**HOLTEC INTERNATIONAL**

**HI-STAR 100 CERTIFICATE OF COMPLIANCE 71-9261**

**CERTIFICATE AMENDMENT REQUEST 9261-1**

Subject: NRC 10 CFR 71 Certificate of Compliance No. 9261, Docket No. 71-9261  
License Amendment Request 9261-1

**FIGURE 5.3.9; HI-STAR 100 OVERPACK WITH MPC-24 CROSS SECTIONAL VIEW SHOWING THE THICKNESS OF THE MPC ~~SHIELD SHELL~~ AND OVERPACK AS MODELED IN MCNP**

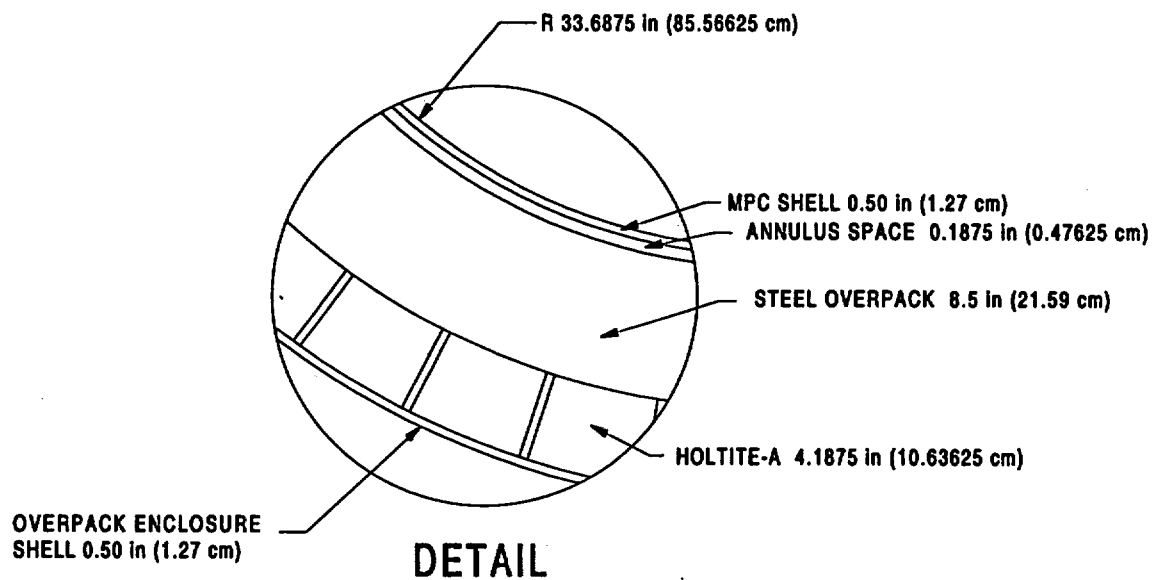
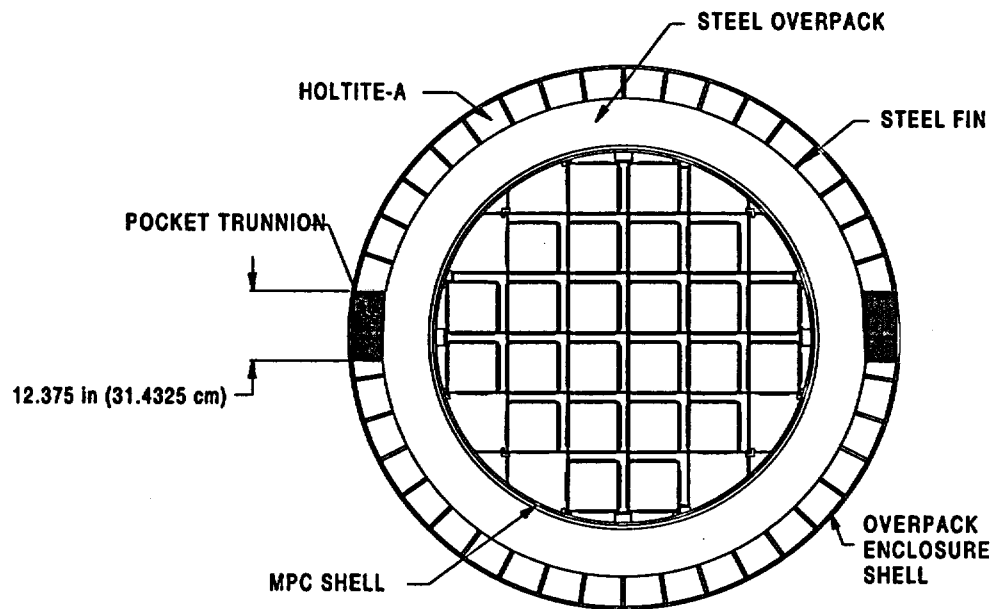
- k. Figure 5.3.9 is revised to correct a typographical error.
- l. New Subsection 5.4.5 is added to discuss the source terms for the Dresden Unit 1 antimony-beryllium neutron sources which are being added to the allowable contents for the HI-STAR 100 package.
